# Rezoning Transportation Analysis

Petition Number: 2020-103

General Location Identifier: 21337101

**From:** Lakisha Hull, AICP, LEED AP BD+C  
[Lakisha.Hull@ci.charlotte.nc.us](mailto:Lakisha.Hull@ci.charlotte.nc.us)  
704-432-5492

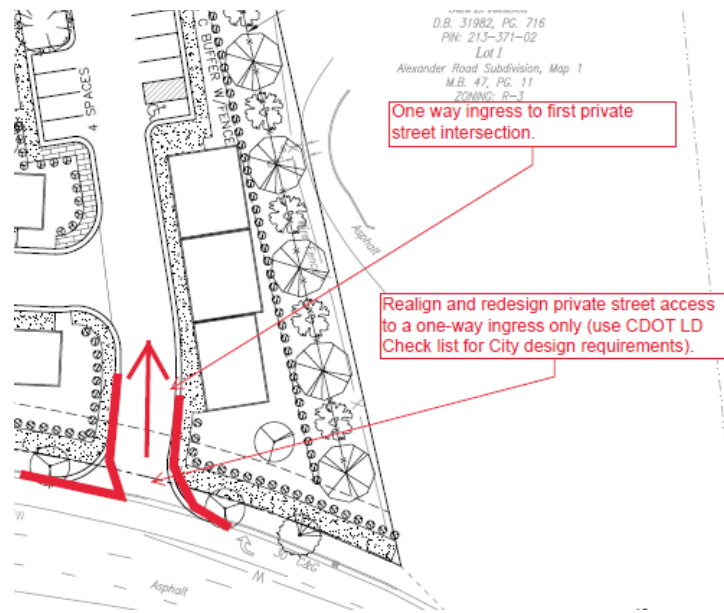
- Traffic Study - Revised Comment (10/26/2020)**: The petitioner submitted a TTM to CDOT staff on 10/15/20. NCDOT has received the TTM as well and their review is ongoing. The petitioner should revise the TTM to address analysis of transit, pedestrian, bicycle, and vehicular safety. The updated TTM should include feasibility of midblock crossing on Providence Road. The petitioner shall contact CDOT for the most recent crash data at the intersection of Providence and Alexander for the analysis, as the crash data referenced in the first TTM is inaccurate. Additionally, the petitioner shall update all trip generation tables with correct unit counts. The petitioner discussed reviewing safety concerns, as per meeting notes from a virtual community meeting held on September 1, 2020. The petitioner shall provide a Traffic Impact Study or a Transportation Technical Memo (TTM) with a safety focus, that will study the design and operation of the proposed driveway to Alexander Road as well as the design of the driveway to Providence Road. The TTM shall also include safety measures for consideration of access and movements at the intersection for mitigating trips generated by this petition. A Traffic Impact Study is not necessary for the

~~complete review of this petition due to the site generating less than 2,500 daily trips. If during the permitting process the site generates more than 2,500 daily trips, a traffic study will be required.~~
